<b>Project design document form (Version 11.0)</b>	
<b>BASIC INFORMATION</b>	
<b>Title of the project activity</b>	Olkaria I Units 4&5 Geothermal Project
<b>Scale of the project activity</b>	<input checked="" type="checkbox"/> Large-scale <input type="checkbox"/> Small-scale
<b>Version number of the PDD</b>	<u>043</u>
<b>Completion date of the PDD</b>	<u>027/09/11/20120</u>
<b>Project participants</b>	Kenya Electricity Generating Company <u>Limited(KenGen)</u>
<b>Host Party</b>	Kenya
<b>Applied methodologies and standardized baselines</b>	ACM0002, "Consolidated baseline methodology for grid-connected electricity generation from renewable sources" (Version 13.0.0) <u>Standardized Baseline: Not Applicable</u>
<b>Sectoral scopes</b>	<u>Sectoral Scope 1: Energy Industries (renewable - /non-renewable sources)</u>
<b>Estimated amount of annual average GHG emission reductions</b>	635,049 <u>tCO<sub>2</sub>e-(tonnes)</u>

## SECTION A. Description of project activity

Figure 34: schematic diagram of electricity and steam metering points

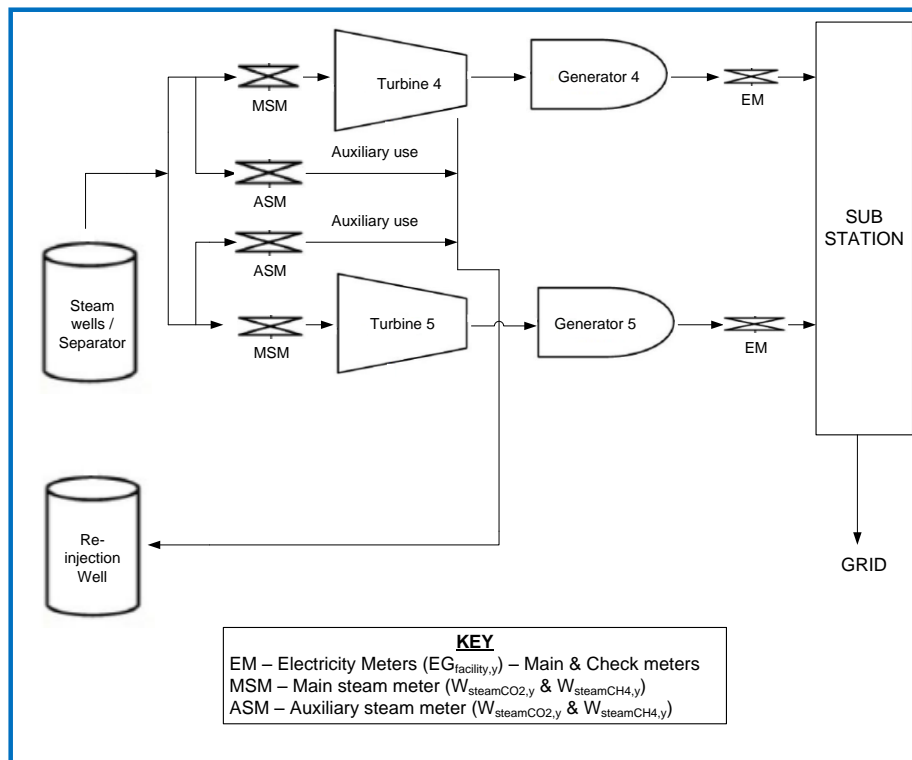
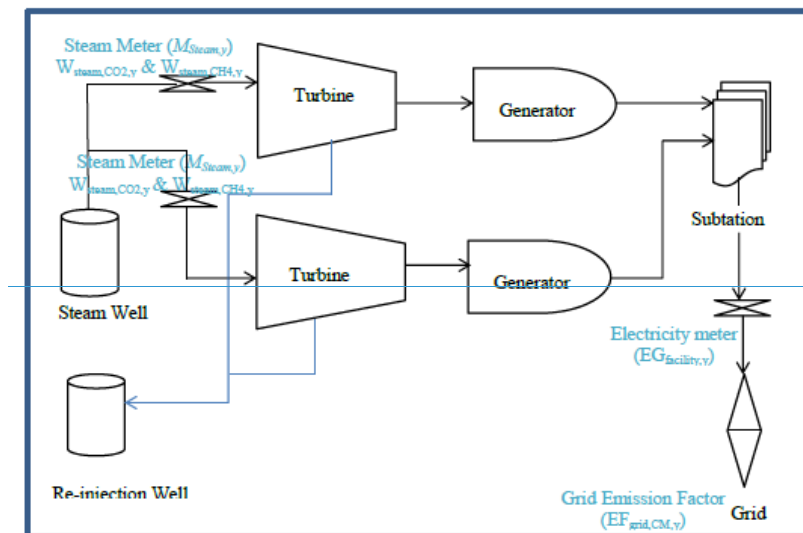
4.  $M_{\text{Steam},y}$  Quantity of steam produced in year y, the location and number of venturi flow meters has been updated in the revised PDD. There are two steam pipelines with their corresponding venturi meters (measuring main steam consumption) for each unit as well as two auxiliary steam pipelines with their corresponding venturi meters (measuring auxiliary steam consumption). Quantity of steam measured by the main venturi meters are being used to determine the quantity of steam produced in year y.

Steam meters will be installed to continuously measure the quantity of steam produced during the year at the power plant. Two sets of venture meters (one main and one auxiliary) will be installed for each unit to measure the main steam consumption and the auxiliary steam consumption respectively. Quantity of steam measured by the main venturi meters and the auxiliary meters will be used to determine the quantity of steam produced in year y (refer to the metering diagram below).~~in the production wells.~~ The meters will have the integration and their readings will be relayed and be displayed in the SCADA. Daily log will be kept electronically. At the end of each month, the records will be retrieved by the Climate Change DM-team leader and be arranged in right format for use.
